## **PD Modification Application:** PRS 26-0008

**Development Services Department**

## **Introduction Summary:**

The applicant is requesting a minor modification to reduce the front yard setback for garages and add an additional access onto County Road 579.

## 8.2 Proposed Site Plan (Full)

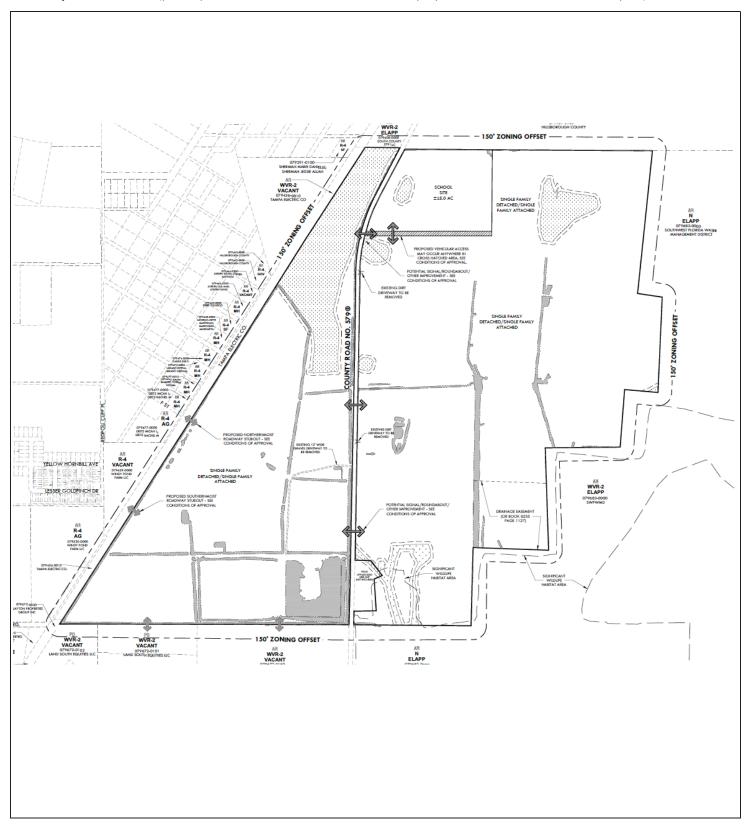
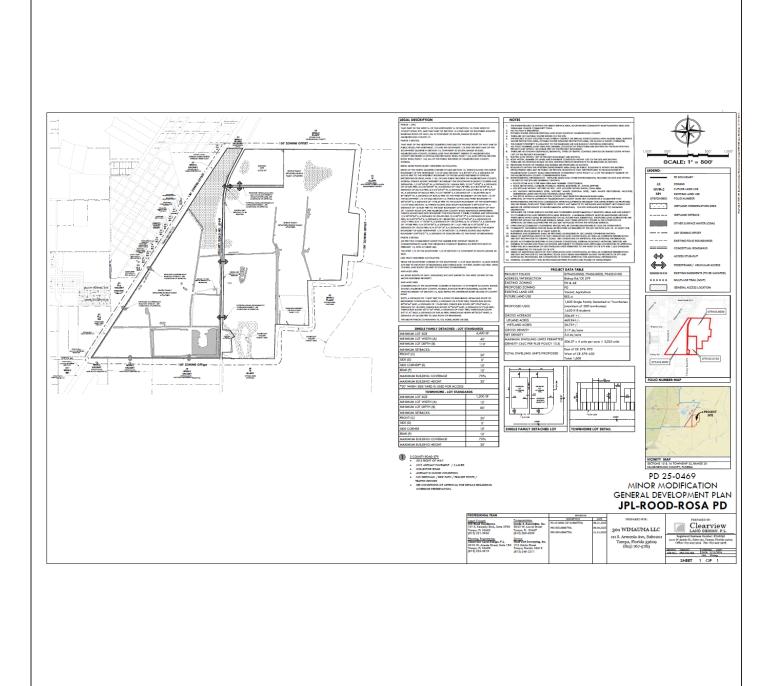
1. Add labels at the proposed (middle) project intersection on CR 579 and label as "Potential Signal/Roundabout/Other Improvement – See Condition of Approval".

- 2. Remove reference to Option B, which looks to increase the number of residential units in place of a K-8 School.
- 3. Remove Note #24 stating additional residential units shall be allowed in the event the School District does not enter into a Dedication Agreement with the Developer for the school site.

#### --Northern Boundary--

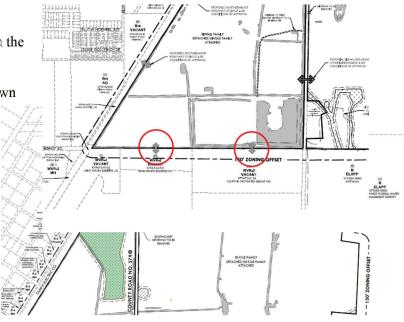
The northern property boundary within the Western Development Area is approximately 400 feet in length (between the TECO corridor and CR 579). Given the connection spacing standards, zero connections are required. Although the applicant is proposing no connections, CR 579 provides north-south connectivity and bifurcates the PD. The entirety of the northern portion of the site within the Western Development Area is shown as wetland/conservation areas. These areas have been shown in green.

## <u>DEMINIMIS DESIGN EXCEPTION – CR 579 SUBSTANDARD ROAD</u>

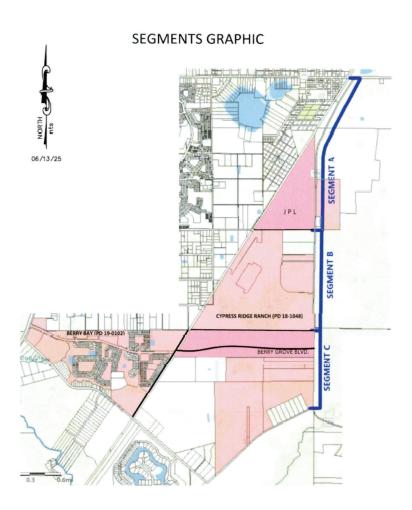
Given that CR 579 is a substandard collector roadway, the applicant's Engineer of Record (EOR) submitted a Design Exception request for CR 579 (dated June 12, 2025) to determine the specific improvements that would be required by the County Engineer. Based on factors presented in the Design Exception request, the County Engineer found the request approvable (on July 8, 2025) and approved the request after BOCC approval of 25-0469 (on October 15, 2025). Given no additional increase in the maximum number of trips generated by the project, no changes in the substandard road improvements are contemplated as a part of this rezoning effort. The request authorized deviations from the 2021 Transportation Technical Manual (TTM) TS-7 Typical Section (for 2-lane Undivided, Local and Collector Rural Roads) including:

- Improvements were split into three segments. Segment A is defined as that portion of CR 579 between SR 674 and the southern boundary of the PD. Segment B is defined as that portion of CR 579 between the southern boundary of the subject PD and the southern boundary of the adjacent Cypress Ridge Ranch project (i.e. adjacent PD 24-1033). Segment C is defined as that portion of CR 579 between the southern boundary of the adjacent Cypress Ridge Ranch project (i.e. adjacent PD 24-1033) and Saffold Rd. A graphic has been provided below to demonstrate these areas.
